**ASSESSMENT REPORT**

**Moolarben Coal Mine  
Section 75W Modification (MP 05\_0117 MOD 8)**

Figure 3: Moolarben Coal Project – Amended Stage 1 Infrastructure Layout

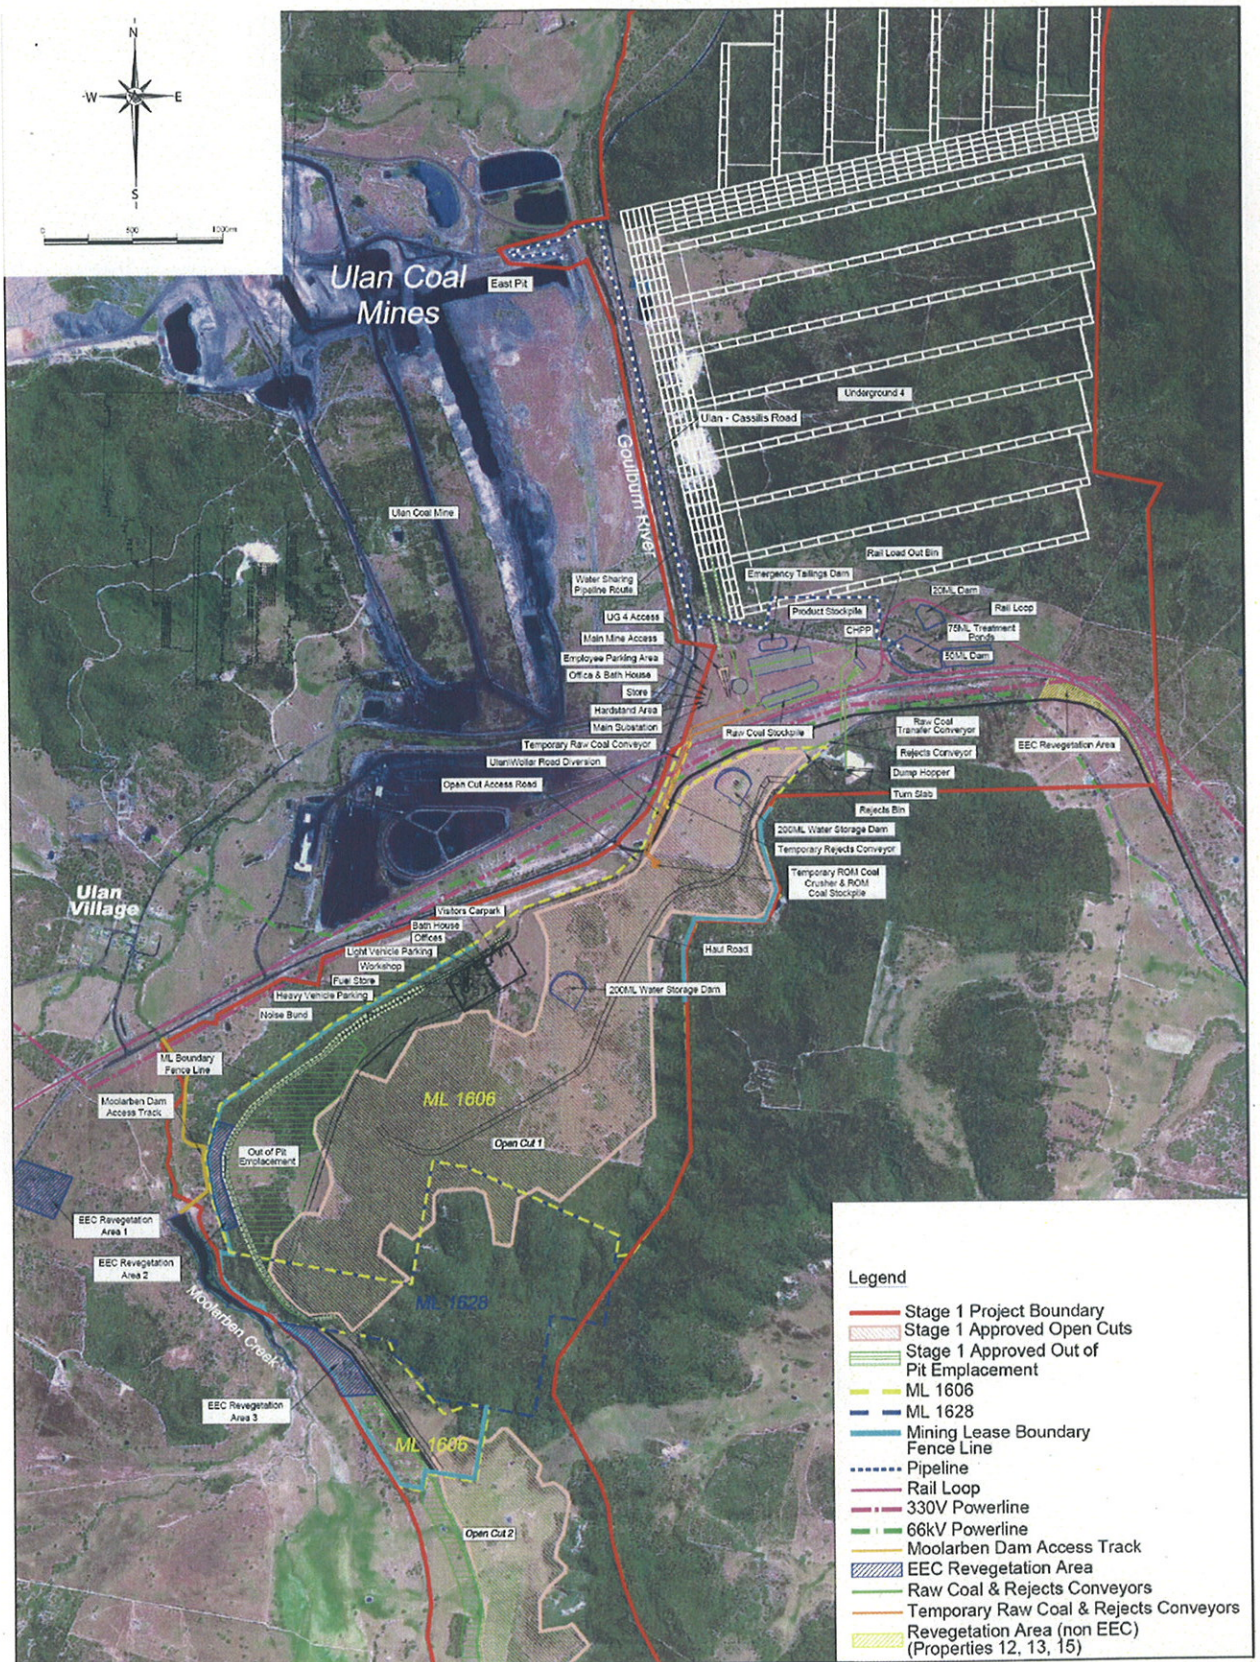
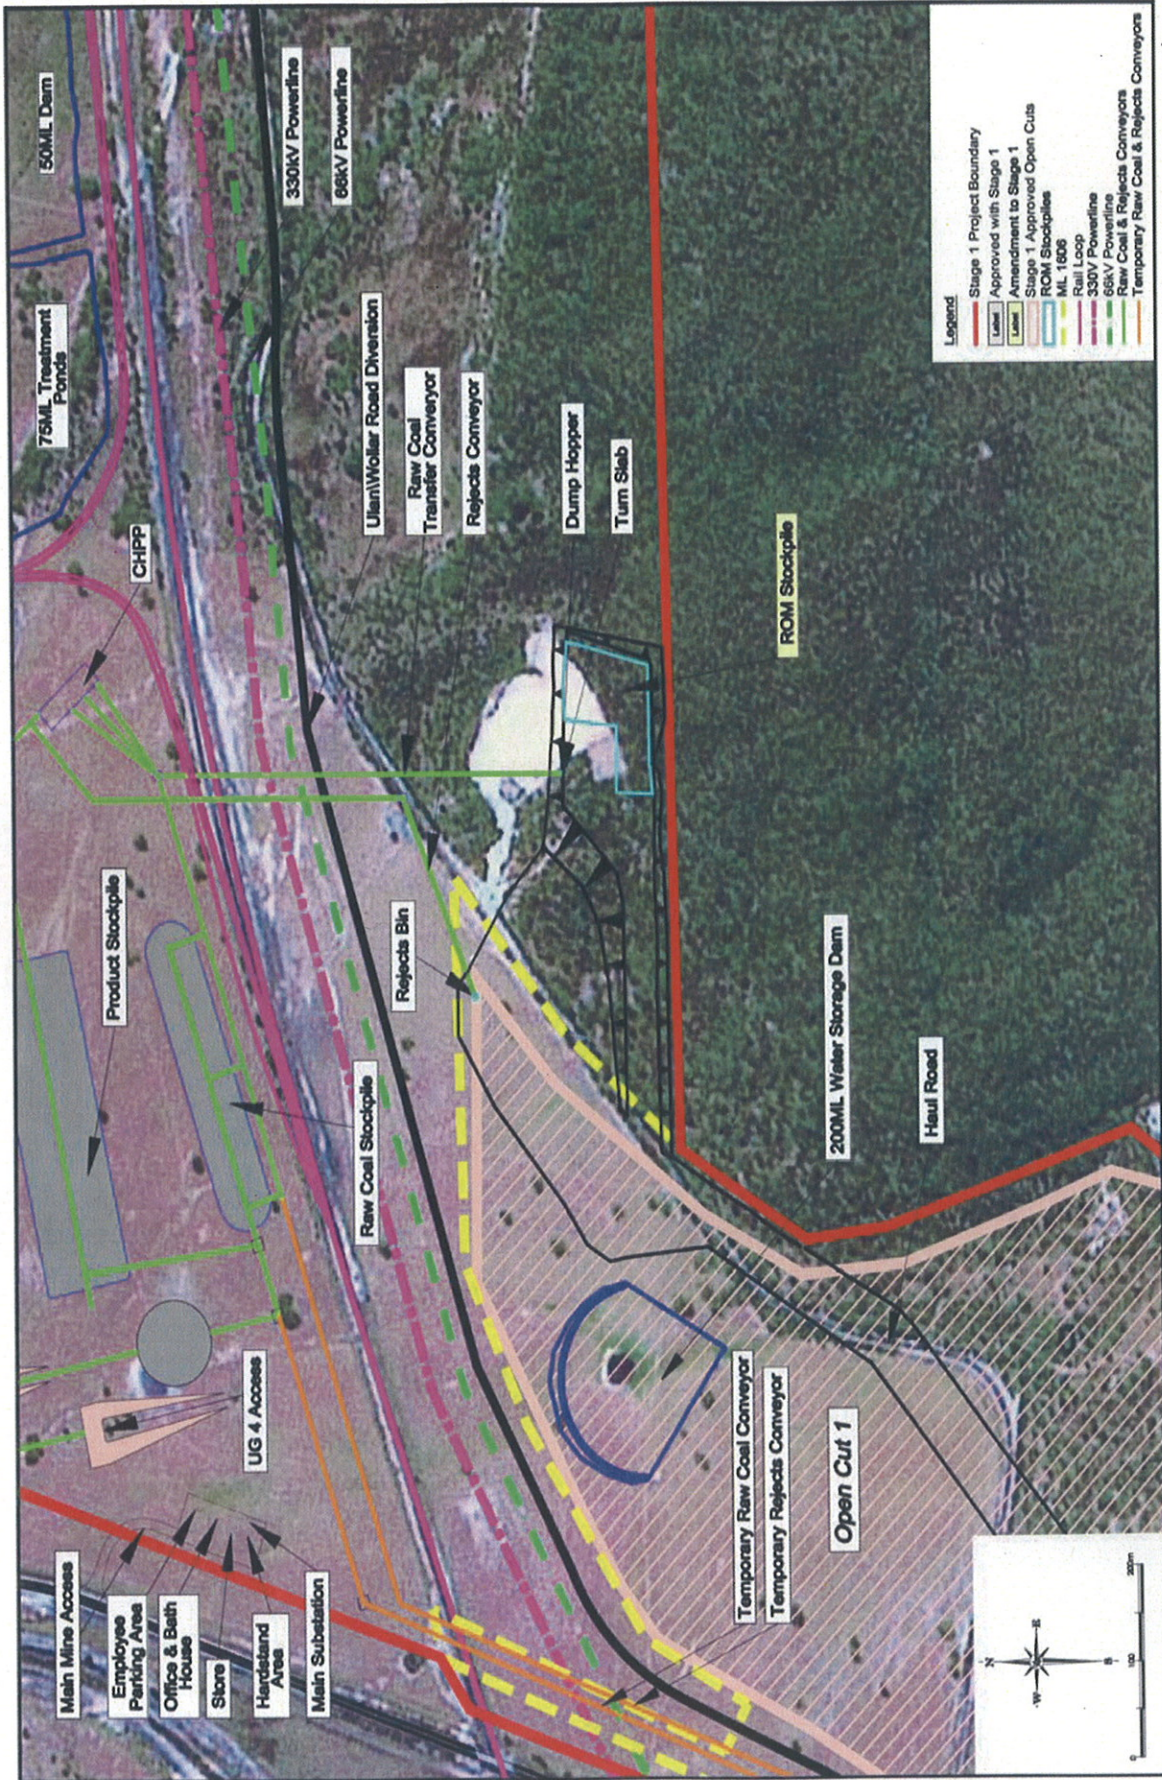
The proposed modification seeks approval to establish a 100,000 tonne ROM coal stockpile adjacent to the ROM coal dump hopper, at the ROM coal facility (**Figures 2 & 3**).

ROM coal stockpiling is required to ensure that a continuous supply of ROM coal is available to the CHPP during potential interruptions in the delivery of ROM coal from open cut pits or the underground mine. The modification would also allow ROM coal to be stockpiled on the ROM coal facilities pad when direct dumping into the ROM coal dump hopper is not available.

In October 2009, the project approval was modified (MOD 5) to relocate the ROM coal facilities nearer to the CHPP and mine infrastructure area (**Figure 2**). At the time of this modification it was anticipated that the ROM stockpiling site proposed under the Stage 2 project application would be used for Stage 1. However, delays in the assessment process for Stage 2 have meant that there is no stockpiling area for the Stage 1 ROM coal.
